CITY OF PORTLAND, OREGON

Land Use Review Appeal to
Portland City Council

Appeal of Design Commission Decision
LU 16-265061 DZM

901-919 SW Taylor Street
The Studio Building and Guild Theater

Condition D: Divided Lites

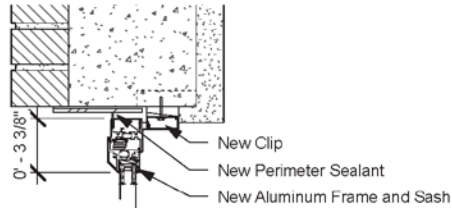
- o **All new windows shall feature simulated divided lights with both spacer bars and interior muntins in addition to the exterior muntins.**
- E. On the West wall, the applicant shall seek a building code appeal to install the Winco 3250 windows or retain the existing steel windows.

The Applicant/Appellant contests the third and fourth bullets of the decision's condition of approval "D" (regarding glass clarity and muntin details) for the following reasons:

1. The appellant believes that the window system as proposed meets the design guidelines and the conditions of approval go beyond a reasonable interpretation of the intent of the code and result in extraneous additional costs for the owner.
2. The appellant states that the City erred procedurally by overlooking the glass sample in the first hearing on January 19, and not bringing up concerns at that time.
3. The appellant contends that the conditioned glass only has a clarity 4% greater than the appellant's preferred glass and does not better align with the Central City Fundamental Design Guidelines.
4. The appellant believes that the part of the condition of approval regarding window system muntins solely impacts the interior of the building which is not within the purview of the Design Commission and not within the scope of the Design Guideline, C3, Respect Architectural Integrity.

1. The Commission believed guidelines A6, C2, C3, and C5 were not fully met without the added conditions.
 - The inclusion of interior and exterior muntins and spacer bars is a standard level of expectation for replacement divided lite windows to retain the character of the existing architecture.

4. Both the existing and proposed windows are operable casements which when open will clearly display the interior muntin or lack thereof. Muntins are also an essential part of the overall window systems of historic buildings.

- It is standard practice in the city to choose replacement windows on older building with interior and exterior muntins and spacer bars in order for projects to maintain architectural character and thus meet the approval criteria.

Original Proposal (Winco 1150S Series)

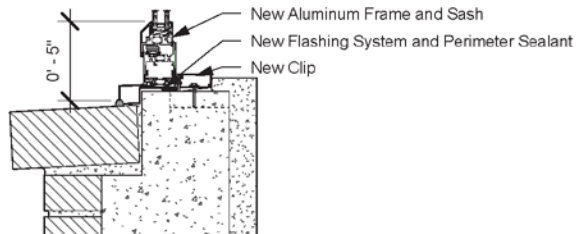
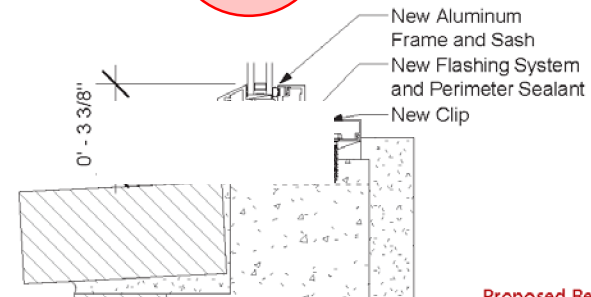
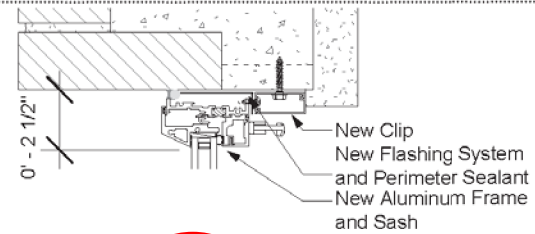
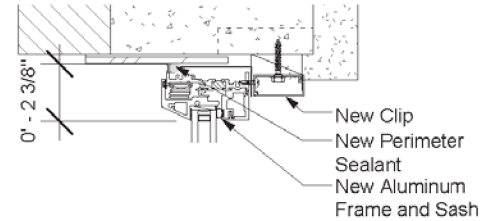
- D. Conditions below pertain to the replacement windows:
 - o The new windows shall be Winco 3250 aluminum replacement windows on all elevations for vertical window conditions;

- o The Winco 3250 aluminum windows shall also be installed in the sloping 9th level condition as elsewhere, unless these windows do not install well in the sloped condition, whereby, the Winco 1150S series can be installed instead;

Condition D: Glass Clarity

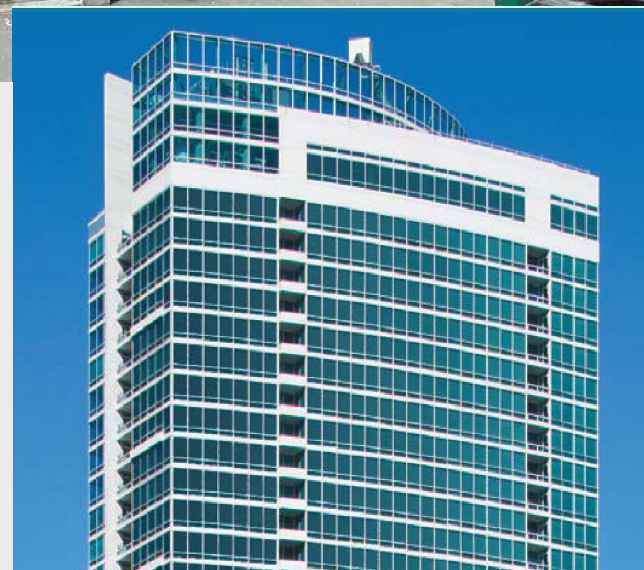
- o **The glazing for all new windows shall have a greater clarity than the sample presented at the March 2nd 2017 hearing, with a clarity comparable to- or greater than- the Solarban® 60 Starphire glass product;**

Replacement windows in historic buildings often appear dark and/or reflective

Windows in historic buildings are usually clear

3. Applicant was asked to return in 2 weeks with a clearer glass sample, but at the applicant's insistence, a condition was composed to enable an approval at that hearing.

- The Commission feels that clearer glazing is critical to maintaining the character of the building as buildings of this age typically have clear glass.

- The condition was crafted as not to be prescriptive of a given glass manufacturer and left leeway for the applicant to choose the clearest glass possible while still meeting energy code requirements.
